ASSESSMENT REPORT

Hillston Solar Farm

Panel Height Modification (SSD 7955 MOD 1)

Figure 1: Project layout, residence and viewpoint locations

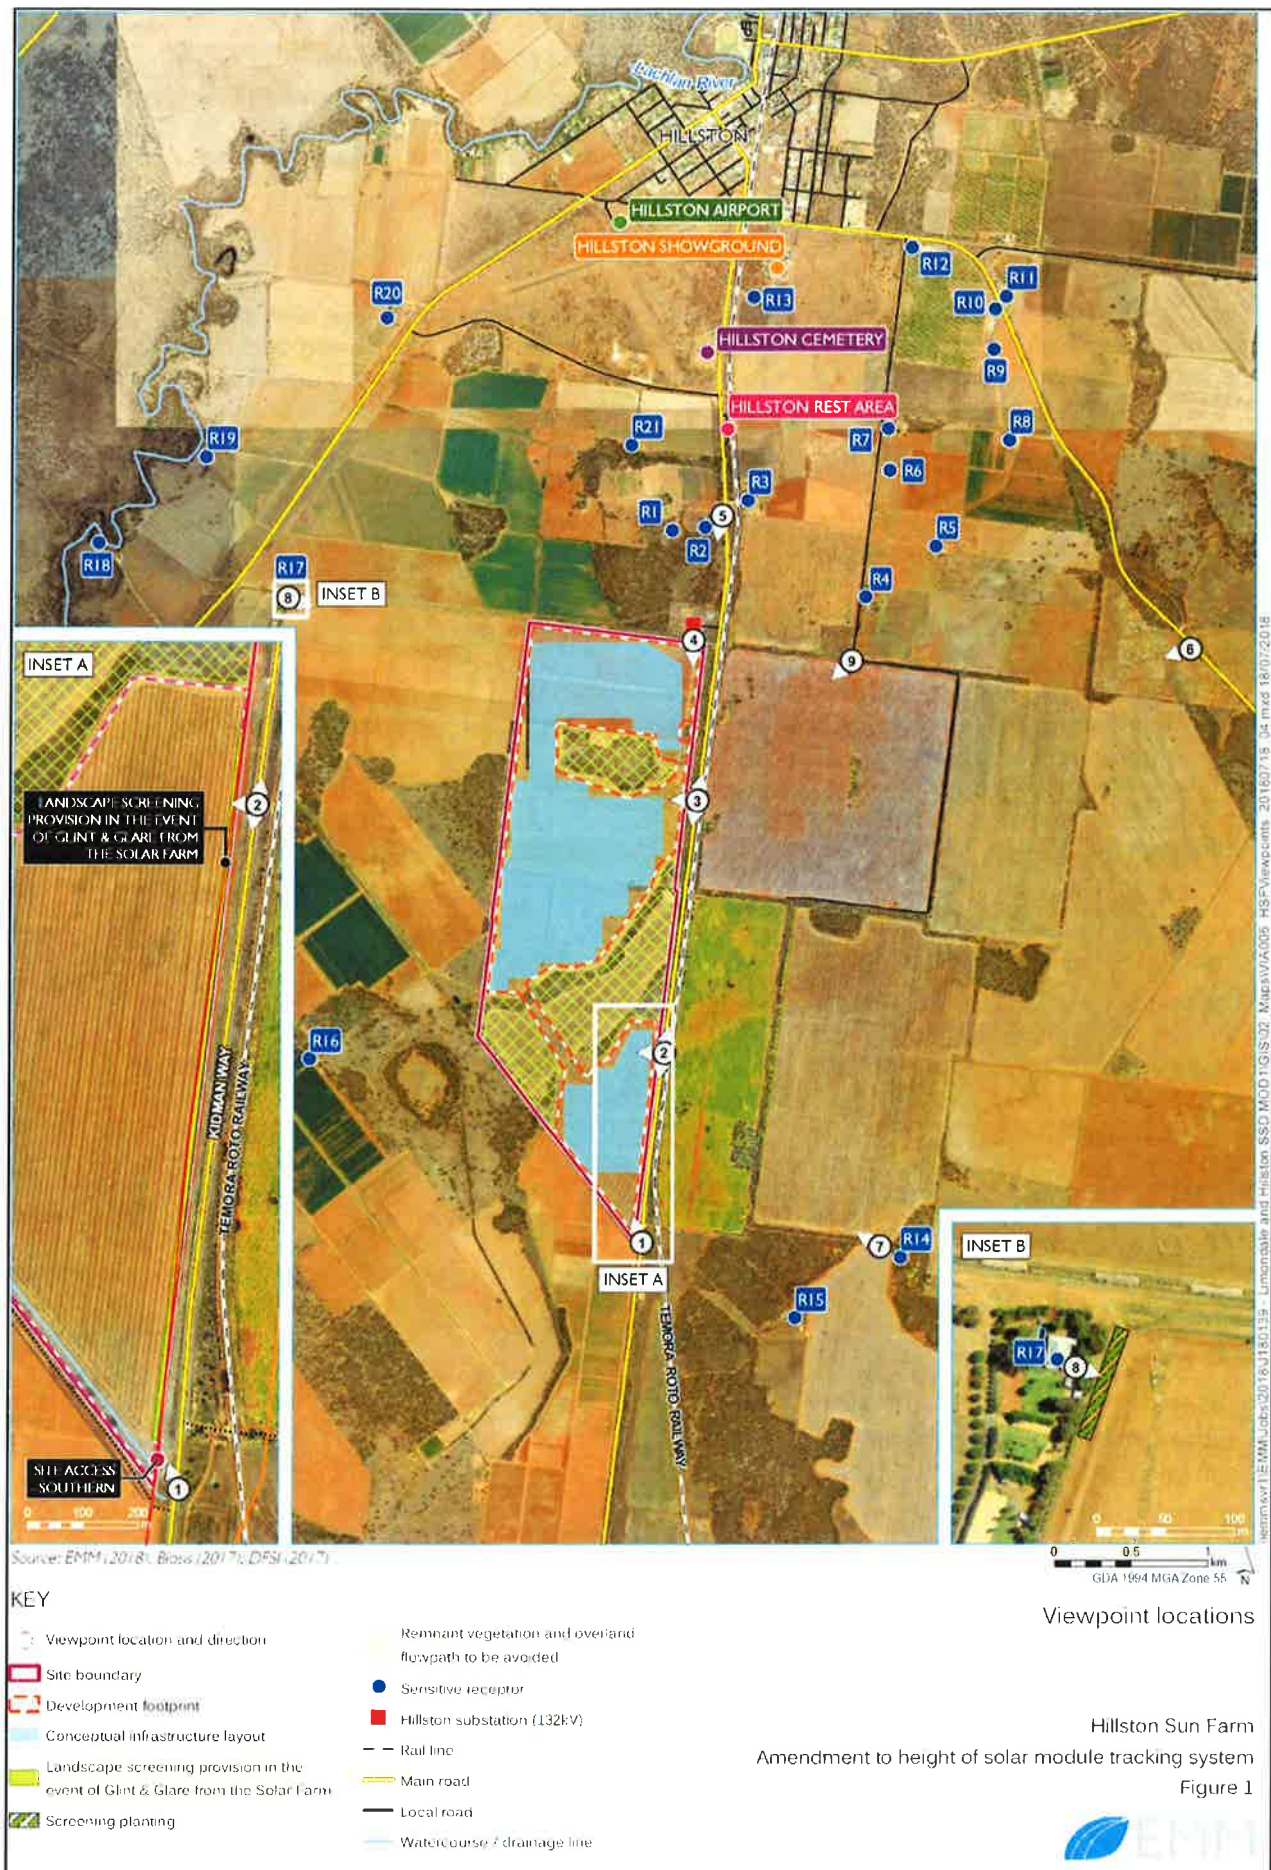
The project site is set in a semi-rural setting along Kidman Way, with 12 residences located within 2 km of the site and the nearest residences R1 and R2 located approximately 700 m north (see **Figure 1**).

Despite the proposed increase in maximum panel heights, existing woodland vegetation would continue to fully screen views from residences north of the project site (i.e. R1, R2, R3 and R21).

Minor increases in the visibility of the project are predicted to occur at dwellings located north-east, south-east and south-west of the site. The Department considers the increased visibility to be minor and manageable given:

- the separation distance between the impacted receivers and additional areas of visibility occur at distances greater than 1.5 km, making the increased panel heights difficult to discern;
- panels would only be at their full vertical position for a small portion of the day;
- the presence of woodland vegetation between the impacted receivers and the project site would continue to provide partial screening; and
- as part of the development consent, the Applicant is required to prepare, establish and maintain a mature vegetation buffer along the northern portion of the site's western boundary and Kidman Way.

While there is no existing screening between the project and dwelling R17 located approximately 1.6 km west of the site, the existing conditions require the preparation of a landscape plan in consultation with the owner and establishment of a vegetation buffer to screen views. Therefore, the Department considers no additional conditions are required to maintain the visual amenity from R17.

As no additional works are proposed in areas outside the approved development footprint, the Department is satisfied that the proposed modification would not result in any significant increase in environmental or amenity impacts.
